SUNDRY NOTICES AND REPORTS ON WELLS

1. Type of Well ☐ ☐ ☐ Gas Well ☐ ☐ Other	NOV -5	2008	8. Well Name and No.	
2. Name of Operator BEPCO, L. P.			BIG EDDY UNIT #213  9 API Well No.	
3a Address	Address O. Box 2760 Midland, TX 79702  Docation of Well (Footage, Sec., T., R., M., or Survey Description)  3b. Phone No. (include area code) 432-682-6373		30-015-36293

## Big Eddy Unit 213 BEPCO, L.P. October 22, 2008 Conditions of Approval

DIAGRAM 2

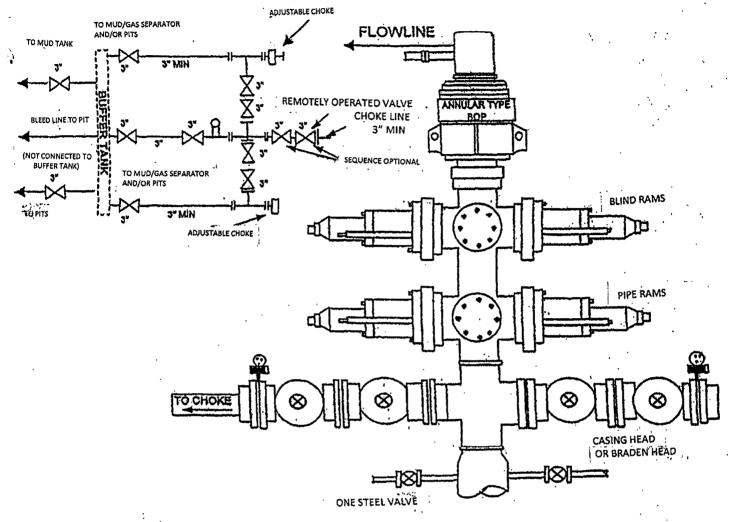
approved disposal site.  2) A BOP equivalent to Diagram 2 will be nippled up Diagram 1 will be nippled up on the intermediate casis			00 psig with the rig pump. A BOP equivalent to	
ACCEPT	ED FOR RECORD		ATTENDED	
			TTACHED FOR	
,,,,	V 5 <b>– 2</b> 008		ITIONS OF APPROVAL	
Gerry Guye,	Deputy Field Inspector	r	·

Based on the MASP that could occur prior to setting the intermediate casing, the surface casing is to be tested to 70% of burst rating as per Onshore Order 2.III.B.1.h (approved for rig pump test) and the BOP test is to be 2000 psi with a third party.
